# Groundwater Application Review Summary Form

Application # G- 18760

GW Reviewer Grayson Fish Date Review Completed: 8/11/2023

TO: Water Rights Section Date 8/11/2023  
 FROM: Groundwater Section Grayson Fish  
 Reviewer's Name  
 SUBJECT: Application G- 18760 Supersedes review of 6/15/2020  
 Date of Review(s)

### This Distance-Drawdown

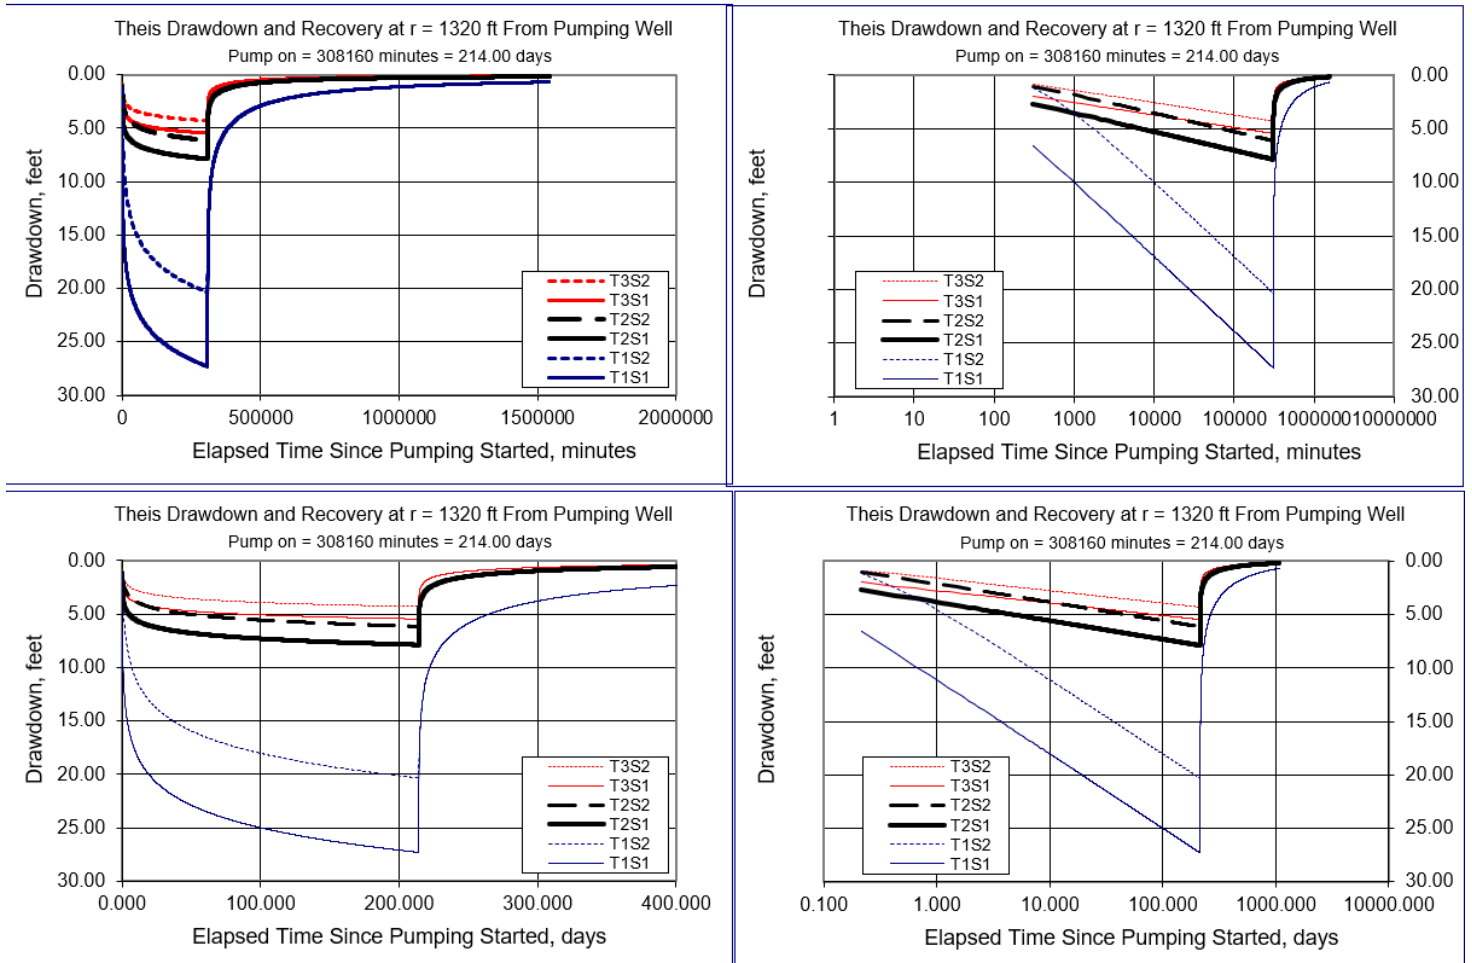
- B3. **Groundwater availability remarks:** The proposed well would produce water from “predominantly basalt layers” which would mean the well would likely extend to a depth deeper than 200’. The well log of KLAM 58670 drilled approximately 1 mile away at a similar elevation of the proposed well encountered water bearing “grey basalt & red cinder” starting at 179’ bls and a static water level of 5’ bls. Static water levels in any given well appears to be controlled by topography and is close to surface water elevation. Groundwater level data is limited in the area, however, KLAM 10521 is located approximately ¼-mile southwest of the POA and groundwater levels in that well have not excessively declined or shown an excessively declining trend. Therefore, a preponderance of evidence does not exist to say that groundwater is over-appropriated. The applicant’s proposed well is located within 1 mile of a densely-developed neighborhood (several 1-acre lots) where most of the tax lots that have been developed have a domestic well associated with them (nearly 40 wells have been drilled in the Section which are concentrated in the southern part near the proposed POA). Approximately 20 tax lots are within ¼ mile of the proposed POA. Many of the well logs for this area report total well depths around 100 to 150 feet and SWLs between 20 and 70 ft (the range of SWLs are more likely controlled by land surface elevation and not vertical changes in hydrogeologic characteristics). A Theis distance drawdown model along with the newly proposed rate of 1.32 cfs as listed in the proposed mitigation plan was used to estimate the magnitude of well-to-well interference that may result from the proposed uses (Theis). Drawdown from the proposed use at neighborhood wells within ¼ mile may be over 5 feet by the end of the irrigation season. It should be noted that this is likely an overly conservative estimate as if the applicant was to exercise their full requested rate of 1.32 cfs they would fulfil their proposed duty of 317.13 ac/ft in 121 days, almost half the expected irrigation season. Regardless, even at the fully requested rate for the entirety of the irrigation season, a preponderance of evidence does not exist to determine injury is likely to occur. Permit conditions should be applied as referenced in B1(d)(i) of this form.

**Hunt Streamflow Depletion**

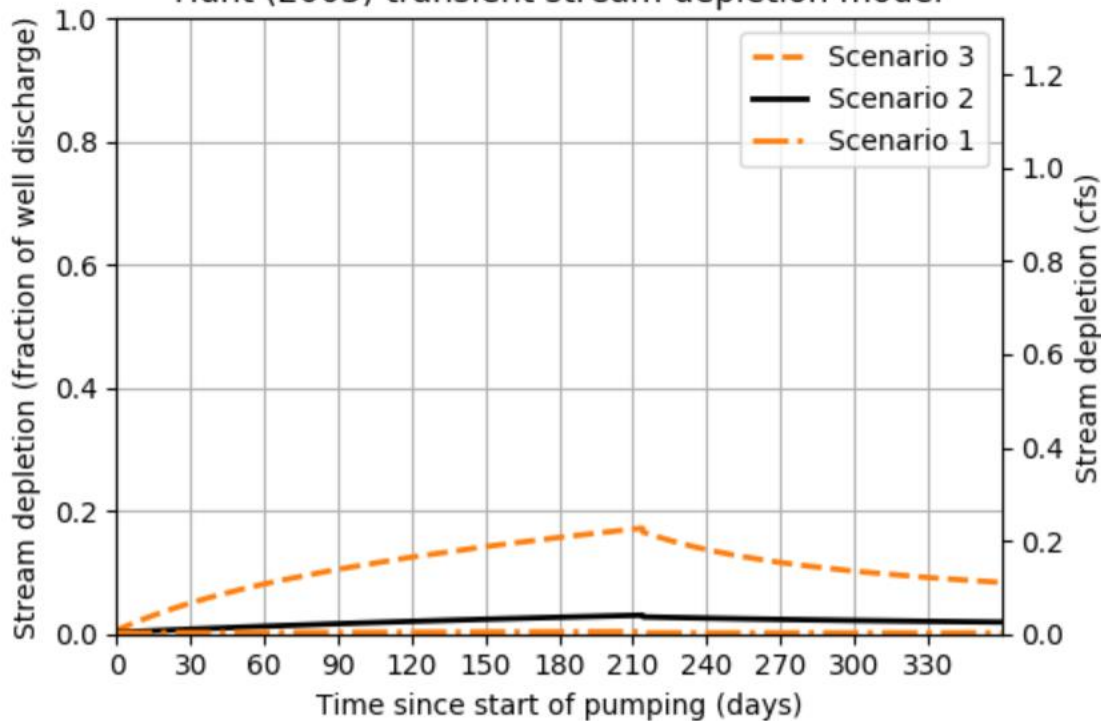
C6. **SW / GW Remarks and Conditions:** The applicant's proposed POA would be producing from an aquifer that has been found to be hydraulically connected to surface water – specifically Fourmile Creek at a distance of less than 1 mile. The proposed maximum rate of appropriation is less than 1% of the pertinent adopted perennial streamflow for the WAB but is greater than 1% of the adopted instream water right for Fourmile Creek. Per OAR 690-009-0040(4) the POA is assumed to have the Potential for Substantial Interference.
